**KIRKWOOD LANDMARKS COMMISSION  
SPECIAL CALLED MEETING MINUTES**

**Case #18-04, 306 E. Jefferson Avenue** (Landmark #5, Smith-Keysor House, Jefferson Argonne Local and National Register Districts) – Alterations and additions to home. Esley Hamilton, the former St Louis County Historian, gave historical background on the home, including the fact that it was one of the first buildings designated as a County Landmark. Comr. Raimist suggested that the Landmarks Commissioners present thoughts on the proposed changes to the house from the meeting on March 14. Ms. Lowry showed historic maps and photos of the property. Comr. Molen reviewed the proposed changes to each elevation and their compatibility to the Secretary of the Interior’s Standards for Rehabilitation (see attached Exhibit A: Molen comments that are incorporated herein). Comr. Raimist also reviewed the proposed changes to the home (see attached Exhibit B: Raimist comments that are incorporated herein) and requested an inventory of what exterior materials will be salvaged and what will be replaced. He said that the house as is does not fulfill Mr. Bruckel’s needs, and the Commission would like to see him get the house he nee

**East Elevation**

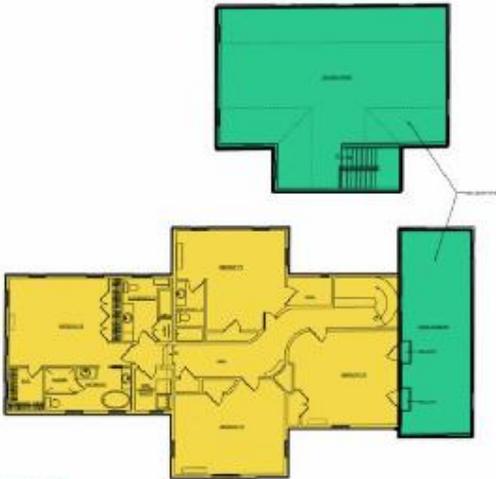
Proposed plans for the east façade include the replacement of the existing porch that spans from the north corner of the gable end to the north corner of the east façade; the removal of a masonry chimney; the replacement of a small window on the existing east façade with a new larger window; the addition of a three car garage, new bath and laundry, rec room and stairs to second floor.

**Standard #2** *which states removal or alteration of historical features should be avoided.* See removal and replacement of existing east porch.

**Standard #4** *changes that have acquired historical significance in their own right shall be retained and preserved.* See removal and replacement of existing east porch.

**Standard #9** *new work shall be differentiated from the old.* See general character and design detailing of garage addition.

The East Elevation is partially retained at the North with the present-day entry door remaining intact, however the porch in this section has been reconstructed to match the style of columns on the South Elevation of the house. The three-car garage with second floor Recreation Room faces the adjacent lot to the East. At left, the one-story Master Bedroom Suite is visible.

**Second Floor Plan**  
*(proposed)*

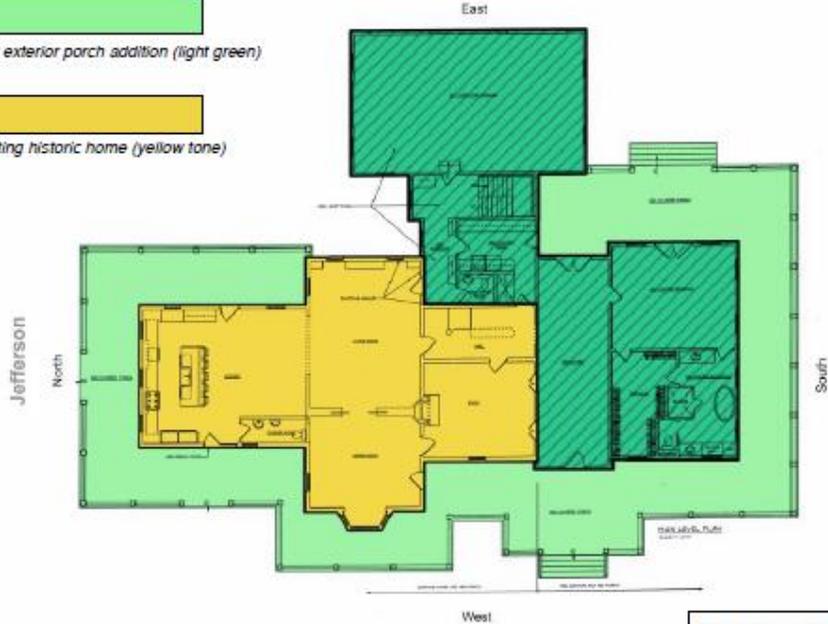
The historic South Elevation is almost entirely obscured and erased by the proposed addition. This was the historical main entry to the house and remains essentially intact today. A two-story addition with the new entry (with its door facing Fillmore) has been added here across this facade. It contains a two-story entry foyer. A one-story Master Bedroom Suite is also proposed to be added here.

To the East is the three-car garage addition with the second floor Recreation Room. The wrap-around porch here imitates the historic one but shifted far to the South. It no longer functions as the entry and the door has been replaced by a window.
